MH Ref: 5105311.00

**Re: 15 Month Common and 2 Year Warranty Review – “ Lotus”
5900 Alderbridge Way & 7371-7373 Westminster Hwy, Richmond, BC**

Lotus - 15 Month Common - 2 Year Warranty Review

Photo 1

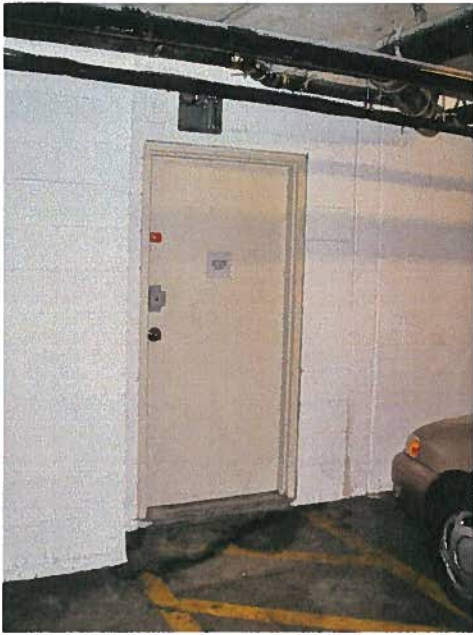
| Photo/ Item | Sample Location | Deficiency Description | Category | Corrective Action |
|-------------|---|--|----------|--|
| 1 | Level P1: Near Parking Stall #54 | Water staining at door threshold / base of wall near Telephone / Television Room. | I | Further review required to determine source of moisture and whether it is building envelope related. |

Photo 7

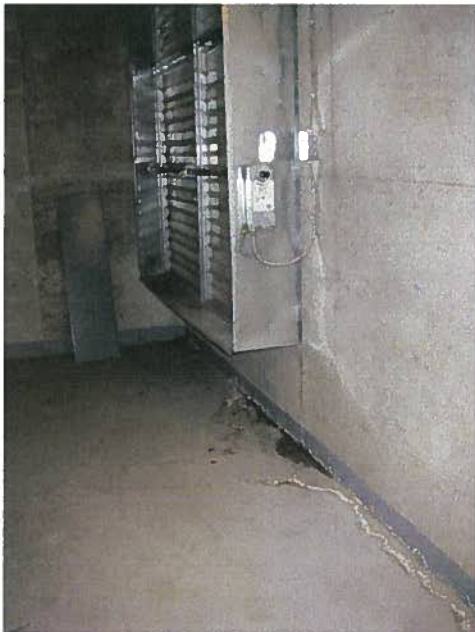
| Photo/ Item | Sample Location | Deficiency Description | Category | Corrective Action |
|-------------|---|---|----------|---|
| 7 | Generator Room | Moisture ingress observed at bottom right corner of louvre along west wall of room. Efflorescence also observed along slab and wall interface. | D | Review and seal perimeter of louvre as required. |

Photo 21

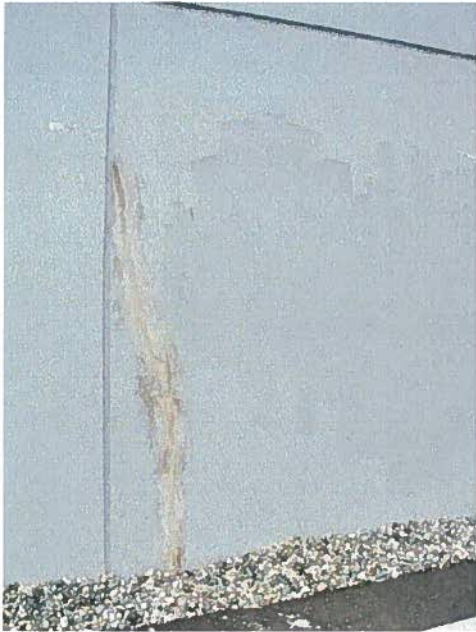
| Photo/ Item | Sample Location | Deficiency Description | Category | Corrective Action |
|-------------|---|--|----------|---|
| 21 | Tower B - East Elevation | Evidence of a previous concrete repair to the concrete wall was observed near the south end of the east elevation. Repair was also done to interior side of wall. | D | The caretaker confirmed repairs were due to water ingress. Repair appears to have rectified ingress. Exterior should be re-coated with elastomeric. |

Photo 24

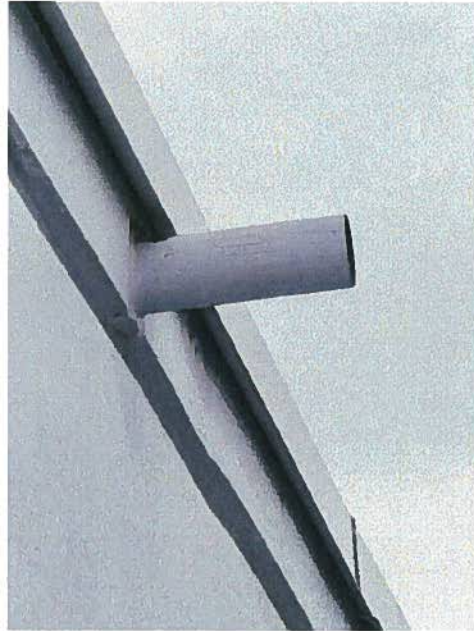
| Photo/Item | Sample Location | Deficiency Description | Category | Corrective Action |
|------------|--|---|----------|--|
| 24 | Tower B Main Roof – Mechanical Penthouse Roof Above HW Tank Room | A negatively sloped scupper pipe was observed at the south side of the Hot Water Tank Room. | D | Scupper pipe should be positively sloped. |

Photo 26

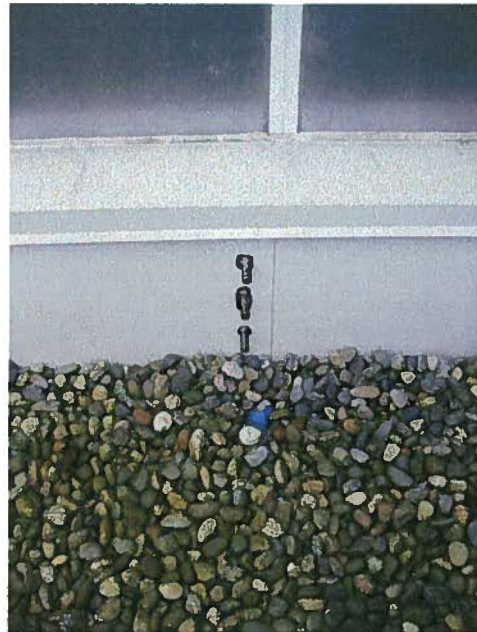
| Photo/Item | Sample Location | Deficiency Description | Category | Corrective Action |
|------------|--|---|----------|--|
| 26 | Tower A Main Roof | A window washing anchor plate was missing at the southwest corner of the glazed rooftop enclosure. Also, the wall mounted window washing anchors are not sealed around the perimeter. | D | Replace missing window washing anchor or rectify metal base flashing (i.e. replace to cover hole in flashing). All wall penetrations should be sealed. |

Photo 32

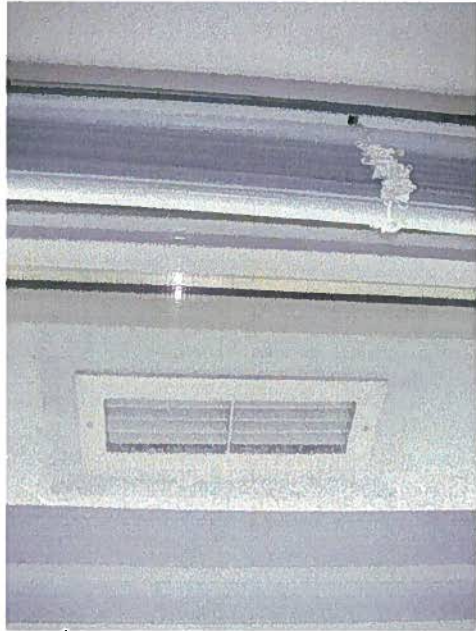
| Photo/ Item | Sample Location | Deficiency Description | Category | Corrective Action |
|-------------|-------------------------------|--|----------|---|
| 32 | Interior Suite Review - B1503 | Hairline crack at underside of north eyebrow at exhaust grille telegraphing through to inside of suite at kitchen / dining area. No current evidence or owner reported issues of moisture from this crack at this time. | M | Monitor crack for signs of staining and or potential moisture ingress. |

Photo 36

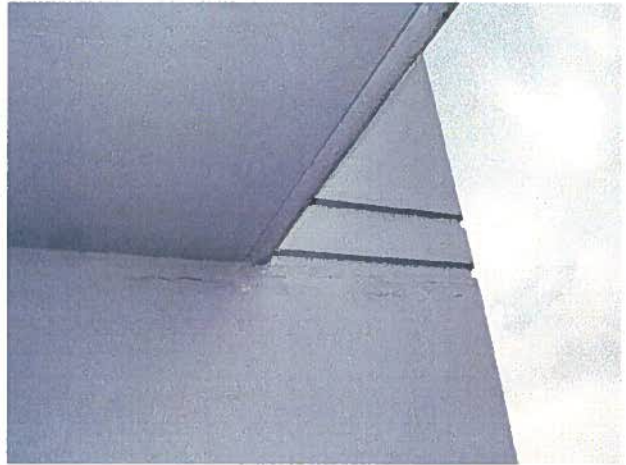
| Photo/Item | Sample Location | Deficiency Description | Category | Corrective Action |
|------------------|---|--|----------|---|
| 36 | Tower C – West Exit Door to Level 5 Courtyard | Owner of Unit C507 pointed out daylight visible between left side of exit door and window frame. Daylight was observed by MH. | D | An air and moisture seal should be provided at the window frame to door coupler per typical design. |

Photo 40

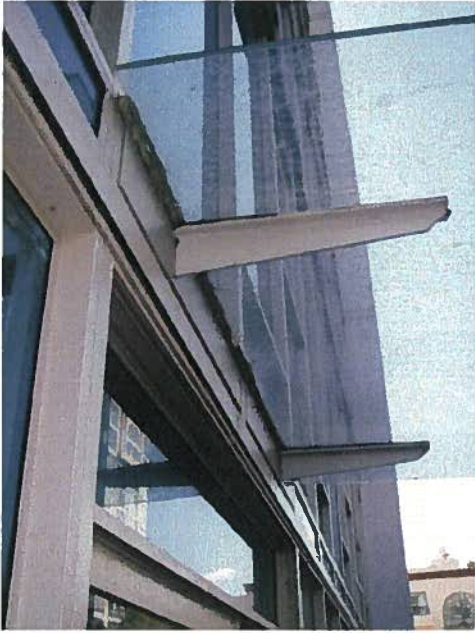
| Photo/ Item | Sample Location | Deficiency Description | Category | Corrective Action |
|-------------|---|--|----------|--|
| 40 | Tower B – Unit B-501 - Glazed Canopy above Sliding Door | The sealant along the back edge of the canopy glazing to window system has failed. Current detail requires regular maintenance of sealant and is not very durable. | D | Re-detail. Consider adding drip flashing above canopy to deflect run-off from window system onto canopy instead of relying on sealant. |

B1

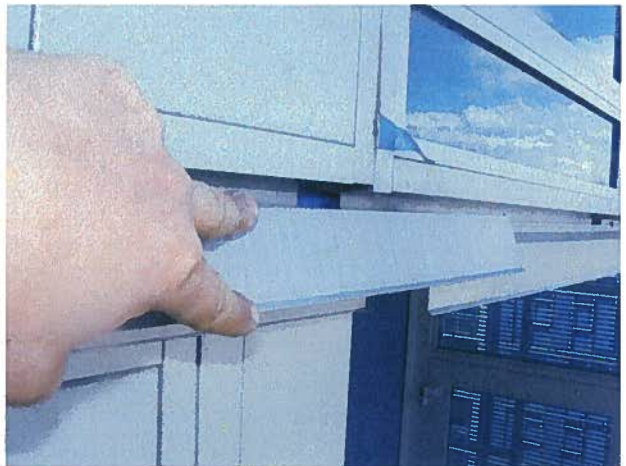
| Photo/Item | Sample Location | Deficiency Description | Category | Corrective Action |
|------------|--|--|----------|--|
| B1 | Tower A – Bosun Chair Drop 1 South – Unit 1805 | Metal sill flashing loose and negatively sloped. Note: In photo, flashing has been pulled out away from blueskin membrane (i.e. blueskin was not exposed to UV). | D | Flashing should be well secured and positively sloped. |

B5

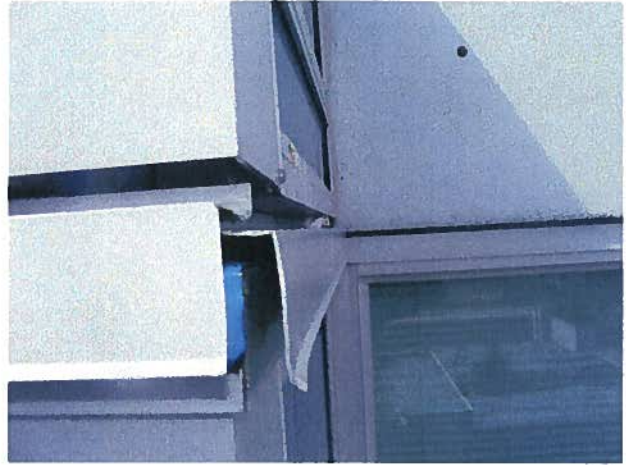
| Photo/Item | Sample Location | Deficiency Description | Category | Corrective Action |
|------------|--|--|----------|--|
| B5 | Tower A – Bosun Chair Drop 2 – East Top Floor Unit | Metal vent hood not painted and showing signs of corrosion. Also, sealant is failing along side of vent hood and missing along transition from concrete to window head in background of photo. Also, elastomeric coating delaminating adjacent to vent hood. | D | Vent hood should be painted and sealant should be provided at transition between concrete and window head. Failed sealant should be replaced and elastomeric coating should be rectified. |

B7

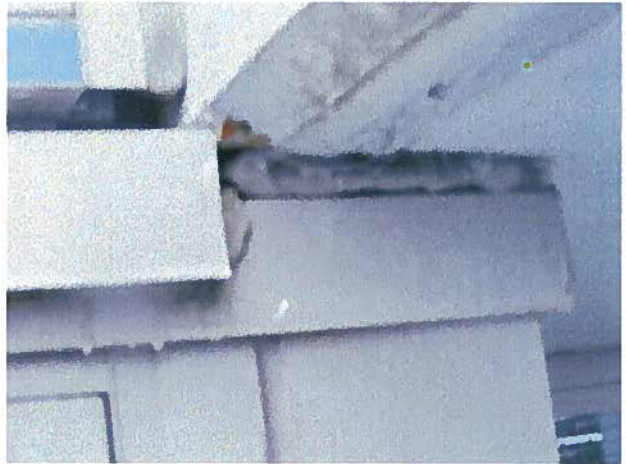
| Photo/Item | Sample Location | Deficiency Description | Category | Corrective Action |
|------------|--|--|----------|--|
| B7 | Tower B – Bosun Chair Drop 4 – East – | Poorly fitted closure flashing at outside corner and flashings negatively sloped. | D | Metal flashings should be positively sloped away from building. |
